PacifiCorp - Stakeholder Feedback Form

2019 Integrated Resource Plan

Docket LC 70

SIERRA CLUB'S COMMENTS ON PACIFICORP COAL ANALYSIS METHODOLOGY

Figure 1. Projected Battery Capital Cost Declines Relative to 2018, PacifiCorp and Lazard

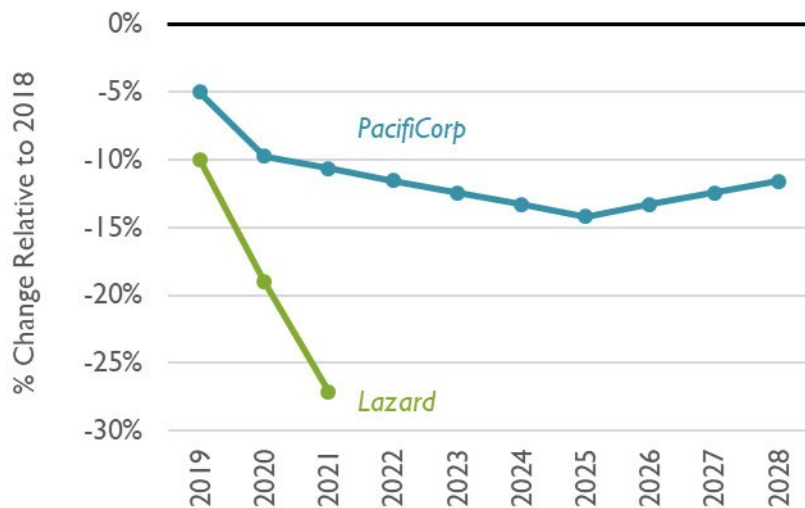
PacifiCorp's assumptions for the current and future capital costs of battery storage resources are too high. PacifiCorp's capital cost trajectory for one megawatt (MW) lithium-ion batteries starts between \$682 and \$1,308 per kilowatt-hour (kWh), depending on the MWh size of the battery.⁶ In contrast, the latest industry-standard levelized cost of storage report from Lazard indicates current lithium-ion capital costs of approximately \$500 per kWh.⁷ PacifiCorp's estimates are about 35 to 160 percent higher than Lazard's estimate.

Furthermore, PacifiCorp uses low estimates for future battery storage cost declines. The Company assumes annual declines of about 5 percent in 2019 and 2020, followed by cost declines of one percent per year in following six years and then cost increases starting in 2026.⁸ Lazard, on the other hand, forecasts lithium-ion capital cost declines of about 10 percent per year between now and 2021.⁹ Thus, between 2018 and 2021 Lazard expects lithium-ion costs to decline by about 27 percent whereas PacifiCorp assumes that battery costs will never be more than 14 percent lower than they are today (see Figure 1).

PacifiCorp will discussed updates to it's model assumptions for battery storage and solar capital costs at the November 1, 2018 public input meeting. Those materials are available on the PacifiCorp's IRP website. As explained in that meeting, PacifiCorp's costs are consistent with market data.
